# Transmission Expansion Advisory Committee FirstEnergy Supplemental Projects

January 7, 2025

# Re-Present Solutions

**Need Number:** APS-2023-029 (s3150.1, s3150.2)

**Need Number:** APS-2023-029 (~~s3150.1~~, s3150.2)

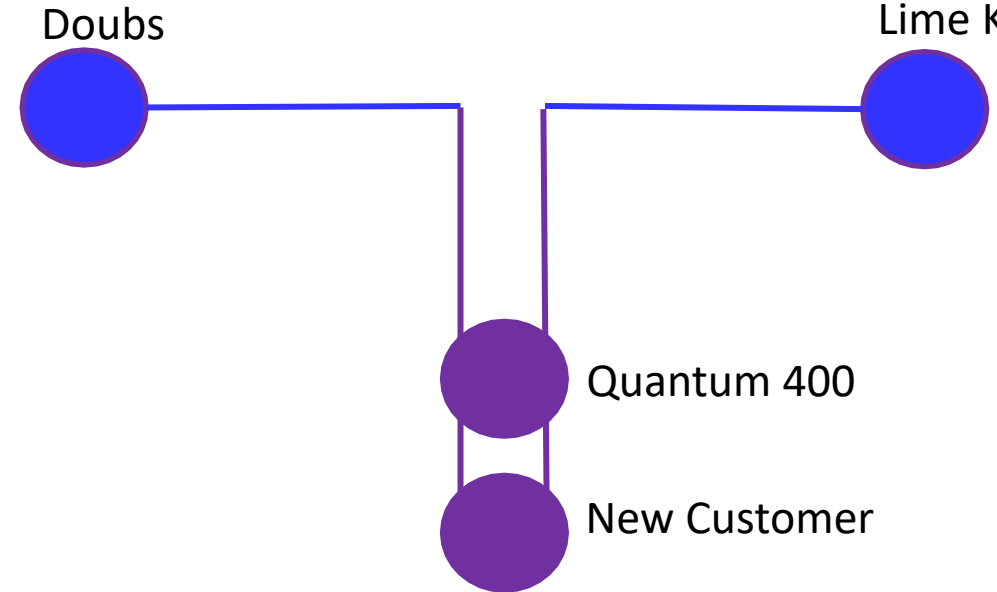
- Build a six breaker, ~~two~~ **three** bay (expandable to four bays), breaker-and-a-half substation (Quantum 400)
- Loop the Doubs – Lime Kiln #231 230 kV Line in and out of the new substation
- Modify line relay settings at Doubs and Lime Kiln substations
- Provide two feeds to the customer facility

**Estimated Project Cost:** ~~\$20.8M~~ 23.2M

**Projected In-Service:** ~~09/01/2025~~ 12/31/2025

**Status:** ~~Pre-Engineering~~ Engineering

**Need Number:** APS-2023-029 (s3150.1, s3150.2)

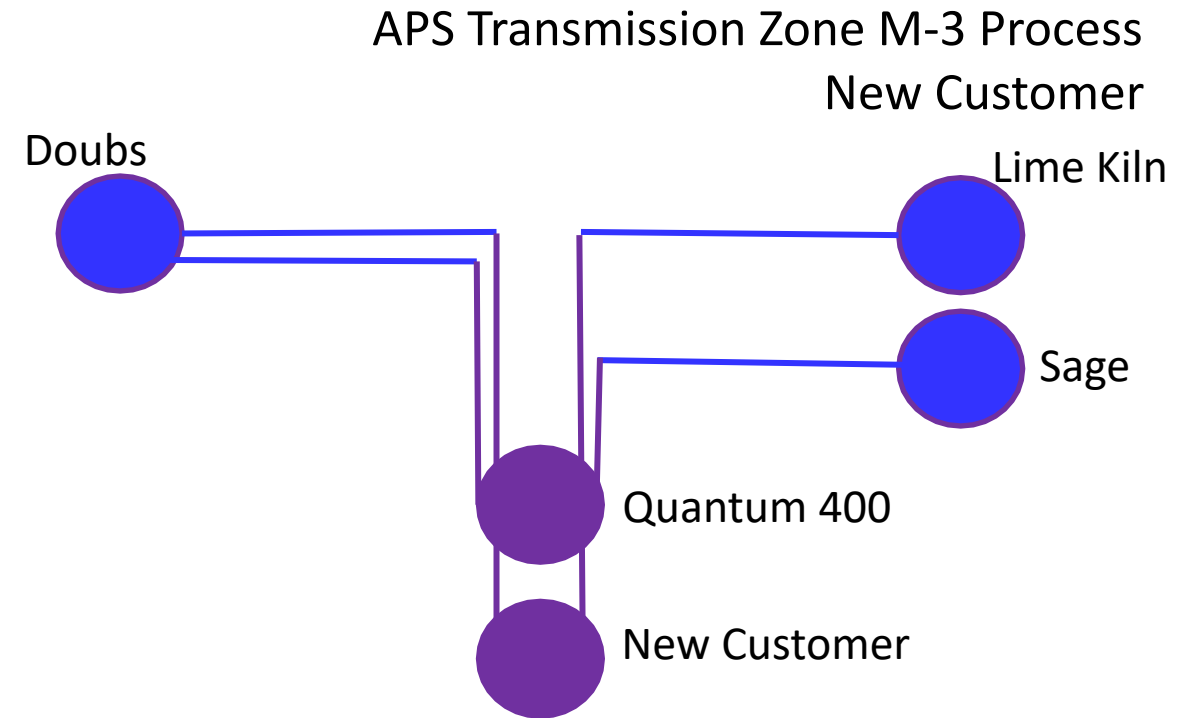
- Expand Quantum 400 station to a ~~nine~~ ten breaker, breaker-and-a-half substation
- Loop the Doubs – Sage #206 230 kV Line in and out of the new substation
- Modify line relay settings at Doubs and Sage substations

**Estimated Project Cost:** ~~\$14.6M~~-\$8M

**Status:** ~~Conceptual~~ Engineering
